# Staff Summary Report

**SUBJECT:** Hold a public hearing for a Planned Area Development Overlay, Use Permits and Development Plan Review for **QUIK TRIP # 1420**, located at 1190 West Elliot Road.

**COMMENTS:** Request for **QUIK TRIP # 1420 (PL090493)** (Rodney Loyd, Quik Trip Corporation, property owner; Juan Romero, Quik Trip Corporation, applicant) for a 5,014 sf. convenience store with a 6,190 sf. fuel sales canopy on a +/- 1.43 acre site located at 1190 West Elliot Road in the PCC-2, Planned Commercial Center General District and the SWOD, Southwest Tempe Overlay District. The request includes the following:

**PRELIMINARY SITE PLAN**

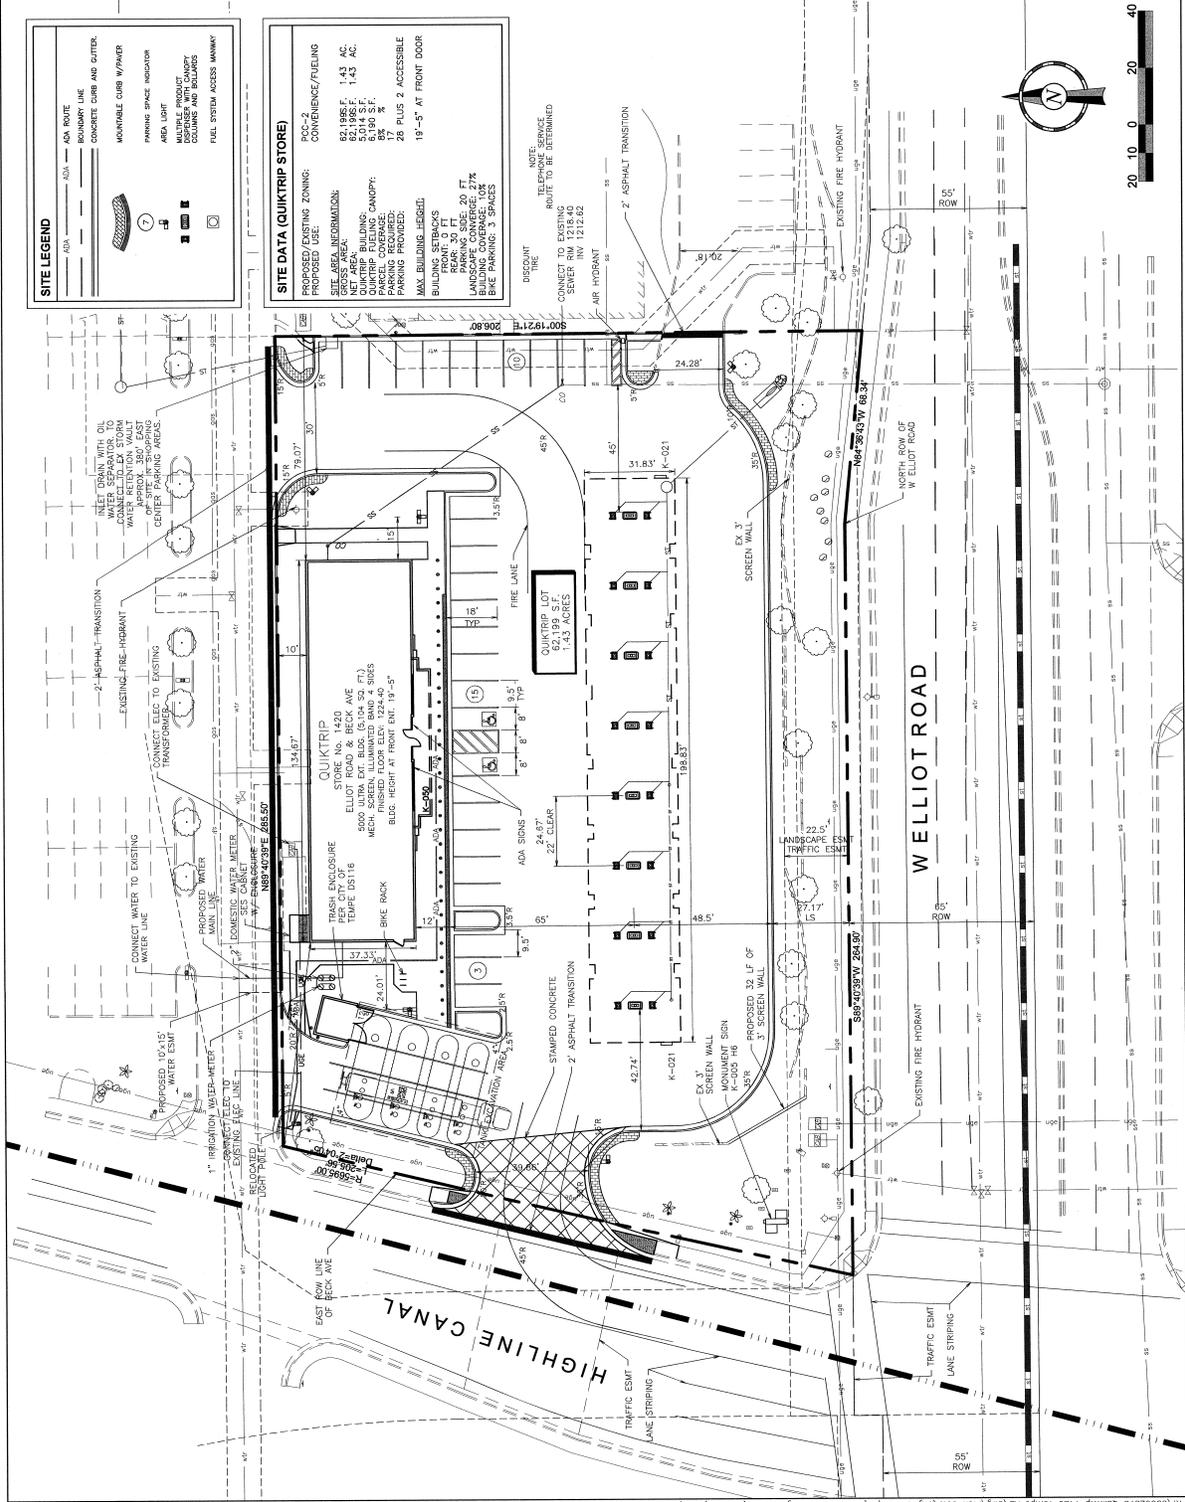
8. Locate an intermediate landscape island in the parking row near the southeast building corner, as indicated in Site Plan Review mark-up, dated May 5, 2010. Ensure that no more than twelve (12) parking spaces are in line between landscape islands in front of building or elsewhere on site.
9. Utilizing a mixture of trees, shrubs and groundcovers, provide minimum fifty (50) percent of evenly distributed mature canopy coverage for all planting areas on site including around base of building and in adjacent public right of way, except provide seventy-five (75) percent mature canopy coverage in required parking landscape islands.
10. Provide a landscape area calculation that demonstrates the landscape area within and surrounding the parking area is minimum twelve (12) percent of the entire on-site paved area.

12. Construct the refuse enclosure in accordance with standard detail DS-116. Use of gates at front of enclosure is not required. If gates are used, metal gates which are translucent by means of a tight metal mesh panel are allowed. These gates do not require a vision panel if the entire translucent panel allows visual surveillance. Refer to the City of Tempe garage refuse enclosure gates at 117 East 5<sup>th</sup> Street (the gates face Forest avenue) for a built example.

13. Locate two bike parking hoops near the south elevation of the store. Separate the hoops so one is near the southeast and one is near the southwest corner of the building. Position the hoops so they are parallel with the face of the south elevation and the 2'-0" by 6'-0" bike parking space associated with each hoop is also oriented parallel with the south elevation. Ensure the hoop and bike parking space are positioned on the walkway so they do not impede pedestrian circulation.

14. Apply diagonal paint stripes to the south parking space adjacent to the air station so it is reserved for air station use. Do not include this striped area as one of the parking spaces.

South Elevation

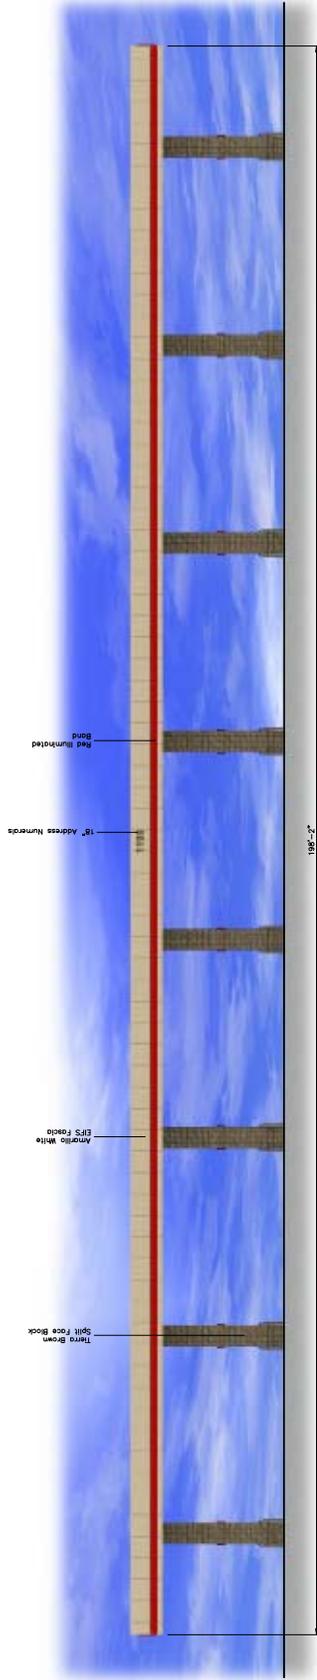
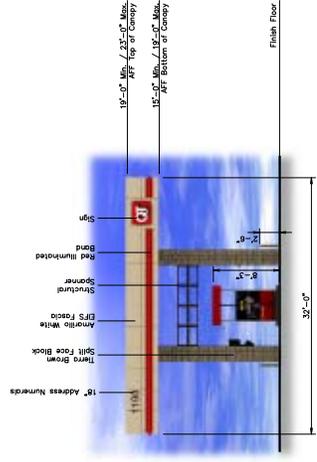
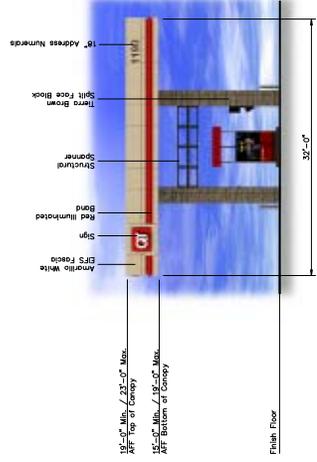
17. The materials and colors are approved as presented:
    - a. Exposed Masonry Accent: Autumn Brown – Smooth Face Concrete Masonry Unit
    - b. Exposed Masonry Field: Tierra Brown – Split Face Concrete Masonry Unit

- c. Exterior Plaster Field: Amarillo White – medium texture.
    - d. Storefront Window Frame: Dark Bronze
    - e. Entrance Door Frame: Stainless Steel

- f. 3M 5674 Red: Accent Band and AwningProvide colors and materials with a light reflectance value of 75 percent or less. Specific colors and materials exhibited on the materials sample board are approved by planning staff. Submit any additions or modifications for review during building plan check process.

19. Locate the electrical service entrance section (SES) on the north elevation inside a masonry enclosure that matches the masonry of the building. The metal door pair of the SES cabinet shall be exposed and flush with the face of the enclosure. The masonry jambs on the sides of the door pair shall be minimum 8" (nominal) width, or one block width. The masonry lintel that extends over the top front of the SES cabinet shall be minimum 1'-4" (nominal) height above the top of the door pair, or two block courses. A vision panel is not required in the cabinet doors.
-
